Re: Comments on "Feasibility Study" and "Proposed Plan for
Remediation", Tutu Well Site, St. Thomas,
Virgin Islands

COMMENTS ON FEASIBILITY STUDY AND PROPOSED PLAN FOR REMEDIATION
TUTU WELL SITE, ST. THOMAS, UNITED STATES VIRGIN ISLANDS
SUBMITTED ON BEHALF OF L'HENRI, INC.

Comments
Final Remedial Investigation (RI) Report
Tutu Wells Site, Tutu, St. Thomas
Report Prepared by Geraghty and Miller (April 1995)
Comments by IT Corporation for L'Henri Inc. (June 7 1995).

Figure S-30
1,2-DCE in deep
April - July 1991

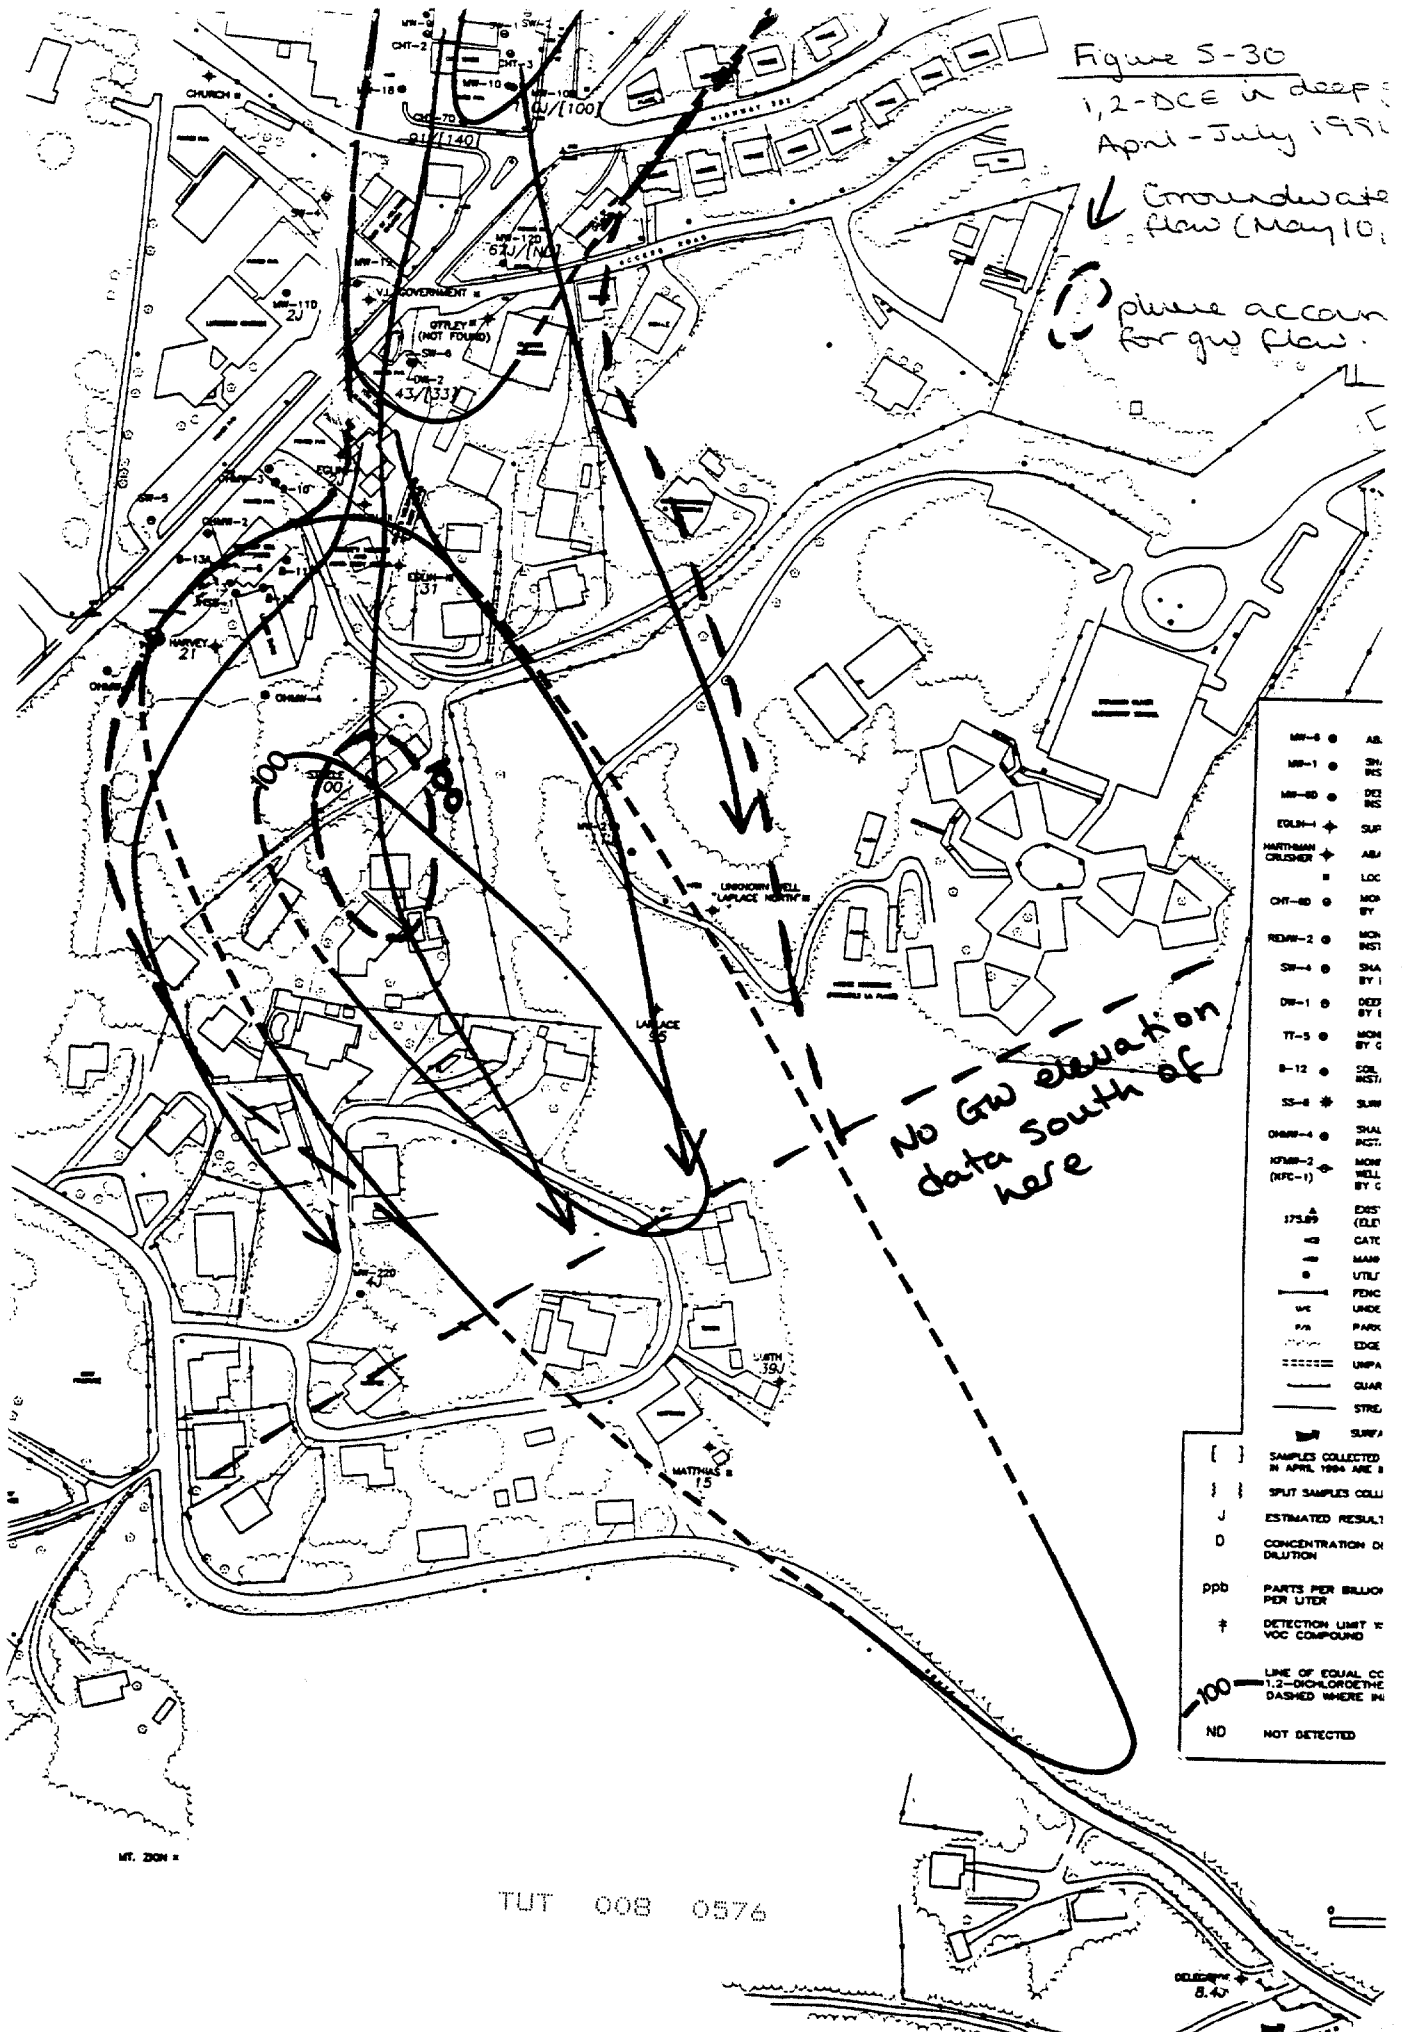
please account
for gw flow

No Gw elevation
data south of
here
